Federal Register

[Docket No. 2001-SW-53-AD]

Airworthiness Directives; Bell Helicopter Textron, A Division of Textron Canada Model 407 Helicopters

ACTION: Supplemental notice of proposed rulemaking; reopening of comment period.

Figure 1. Preflight Check of the tailboom

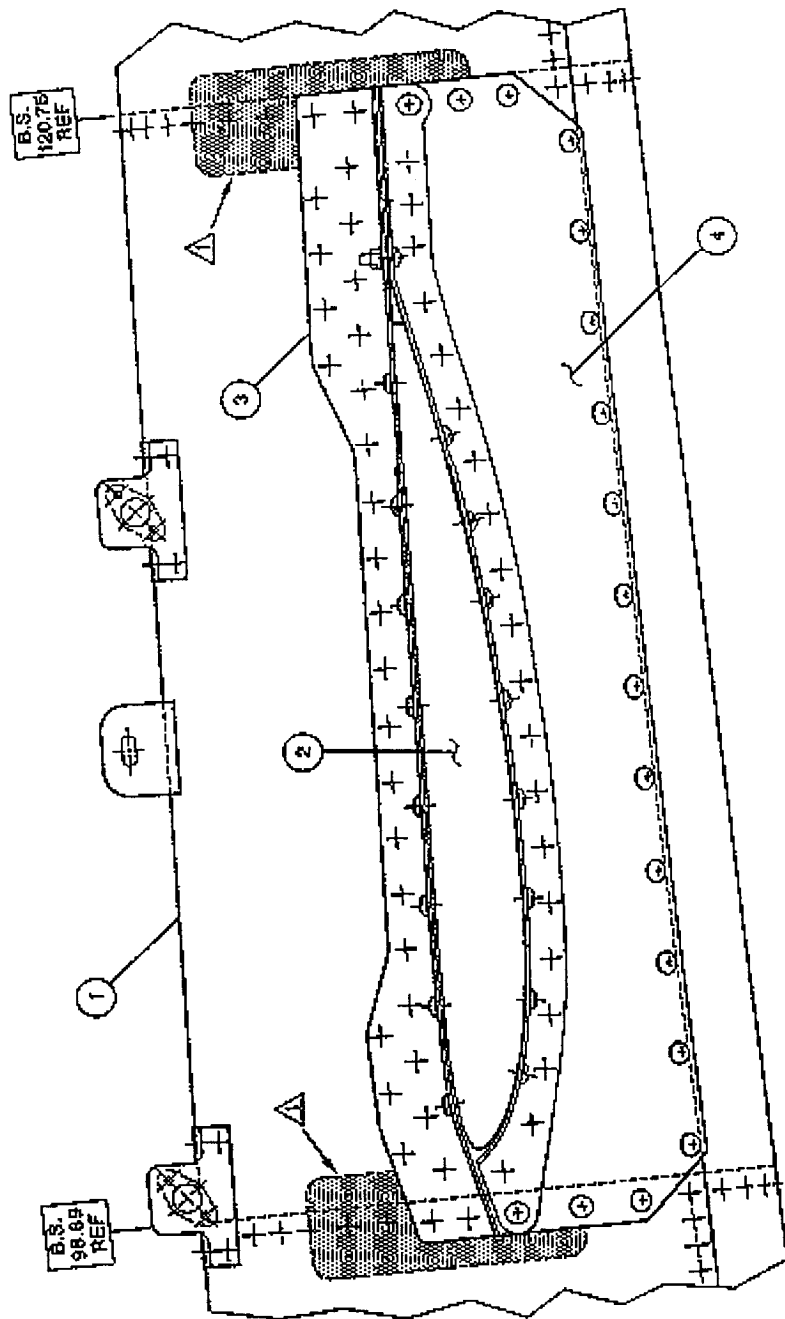
Applicable tailboom	Compliance time	Actions	In accordance with
(a) Tailboom, P/N 407-030-801-101 and -105, that have not been modified in accordance with Bell ASB 407-01-048, Revision B, dated April 25, 2002.	Before the first flight of each day	Visually check the tailboom for cracks. An owner/operator (pilot) holding at least a private pilot certificate may perform the visual check required by this paragraph, but must enter compliance with this paragraph into the helicopter records in accordance with 14 CFR 43.11 and 91.417(a)(2)(v).	Figure 1 of this AD.

- Δ Examine these areas for cracks on left side of tailboom only.
- 2. Horizontal stabilizer not shown for clarity.
